SENENICH PROPELLER CO., INC.

SERVICE BULLETIN SB2019-02

SUBJECT: Inspection of adjustable pitch hubs for cracks

Figure 1. Cracks start near pitch marks and grow outwards.

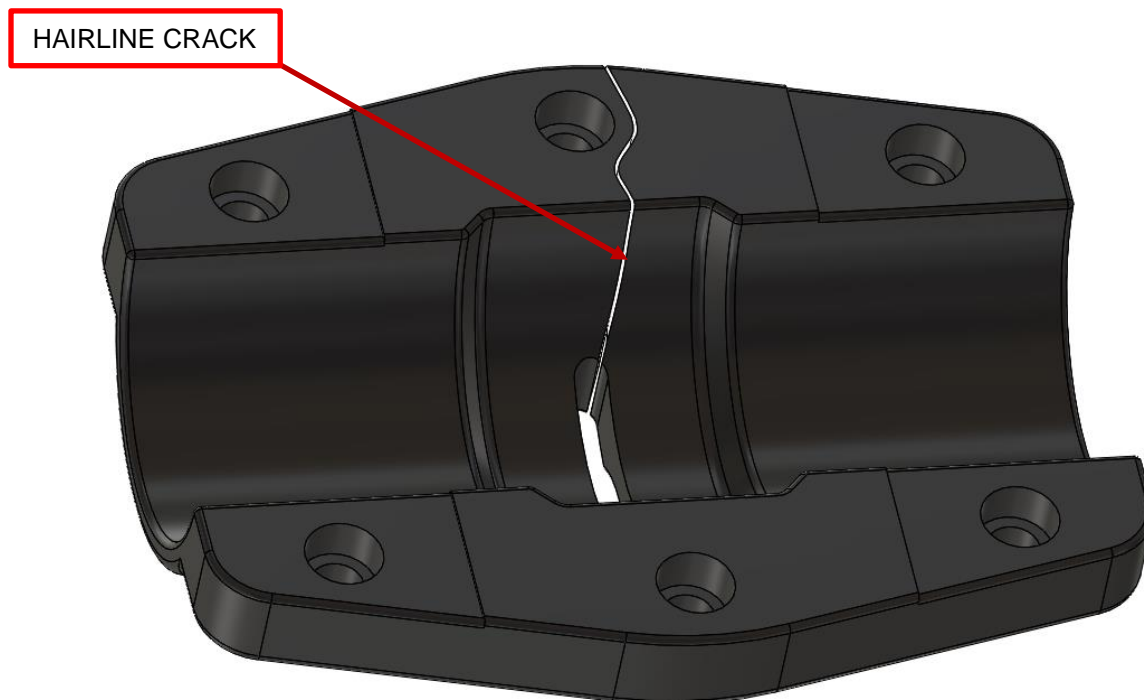
- The hub cracks typically start at or near the pitch cartridge slot on the sides of the central hole, and grow outwards towards the hub sides. They are hairline cracks which are very difficult to see with the naked eye. Refer to Figures 1 & 2 for crack location.

- Using very good lighting and a 10x magnifying glass, inspect the inside of the pitch cartridge slot in the hub cover next to the pitch marks.
- The hub cover must be removed from the propeller assembly for thorough inspection inside the pitch cartridge slot. Inspection of the hub exterior is not adequate.

- Notify Sensenich of any crack occurrences and return affected hub for evaluation.
- Inspect affected hub for cracks every 50 hours or annually, whichever comes first.

Figure 2. Unattended cracks may progress to edges of hub cover half.

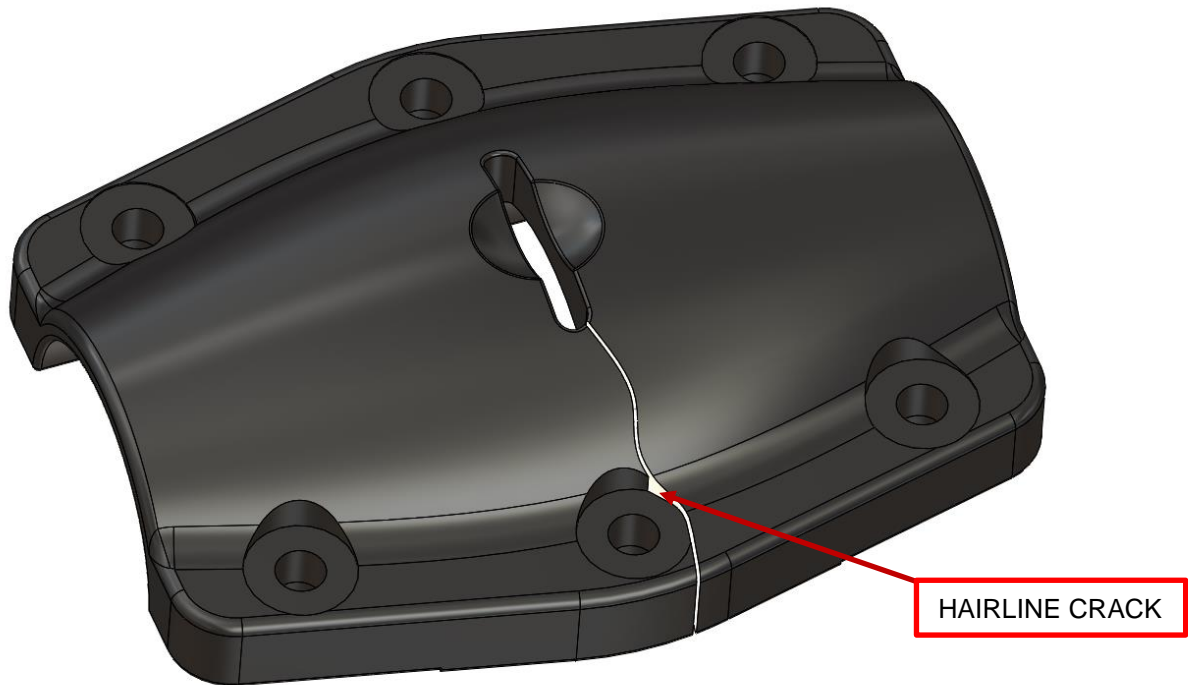
- The occurrence, if unattended, could result in the hub cover half cracking completely across.
- To date, there have been no inflight blade separations but the location of crack growth necessitates immediate inspection.
